**BIDDING FOR THE CONSTRUCTION OF SEABEES (NCEBDe) FACILITIES
AT NSLG ZAMBALES**

BID BULLETIN NO. 03

This Bid Bulletin contains clarifications raised during the Pre-Bid Conference held on 24 August 2023, as well as queries sent by prospective bidders via email, and other matters relating to the Project.

Q10. Seabees Tactics Office and Laboratory

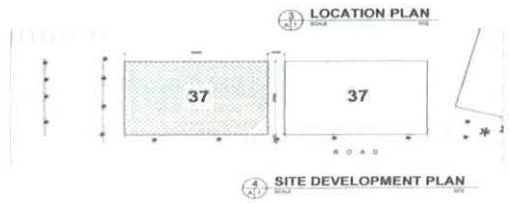
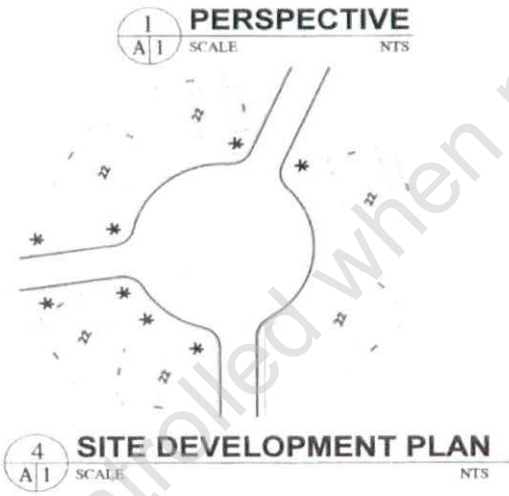
Please verify if this is composed of two (2) structures or just one (1). In the Site Development Plan, it is shown as 2 structures.

Only 1 structure for the Seabees Tactics Office and Laboratory will be constructed under this Project.

Please refer to **Annex A** of this Bid Bulletin for the updated Site Development Plan and **Annex C** for the list of facilities to be constructed.
